RE: 9101 Central Ave NW

Grading and Drainage Plans Engineer's Stamp Date: 01/10/24

Hydrology File: K09D002

Based upon the information provided in your submittal received 01/12/2024, the Grading & Drainage Plans **are not** approved for Building Permit and Grading Permit. The following comments need to be addressed for approval of the above referenced project:

C-100

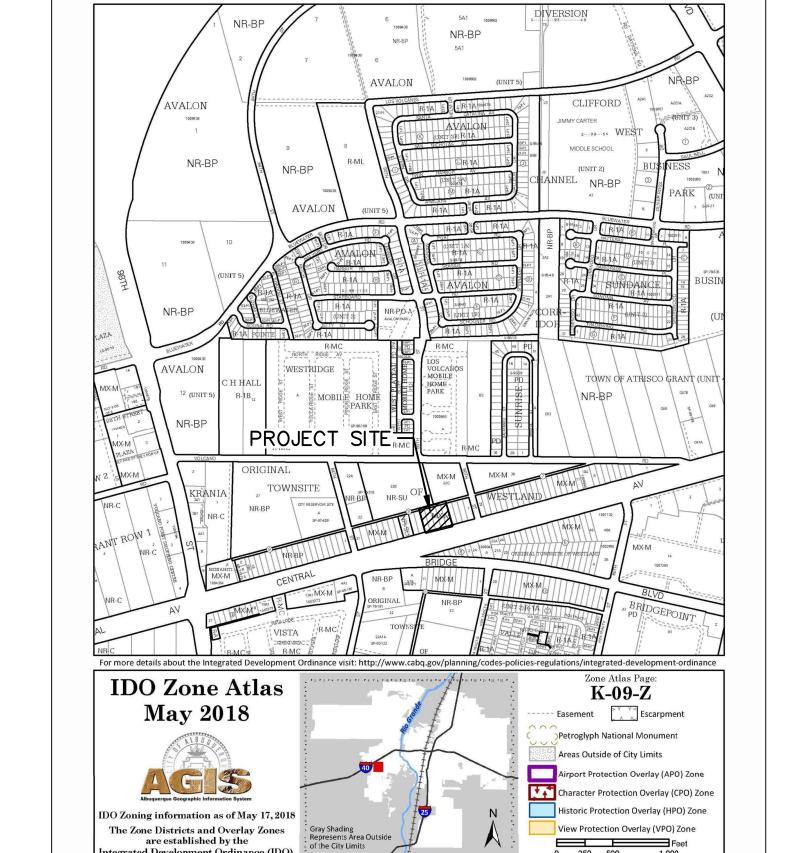
- 2. Please use the procedure for 40 acre and smaller basins as outlined in Development Process Manual (DPM) Article 6-2(a). Please provide both the existing conditions and proposed conditions for the 100 year-6 hour storm event.

- 3. Please follow the DPM Article 6-12 Stormwater Quality and Low-Impact Development for the sizing calculations. To calculate the required SWQV, multiply the impervious area (Square feet) draining to the BMP by 0.42 inches for new development sites divided by 12 to get the required volume in cubic feet. The calculations of both the required and the provided volume of each BMP must be shown on the Grading and Drainage Plan. Each BMP should be labeled on the Grading and Drainage Plan with the required SWQV and associated water surface elevation and the 100-year water surface elevation. Landscaping of surface BMPs is also required to be noted on the Grading and Drainage Plan.

- 8. Under the Existing Conditions, please state that this site is within the Amole-Hubbell Master Drainage Plan by Wilson (2013) and has a discharge rate of 4.11 cfs/ac.
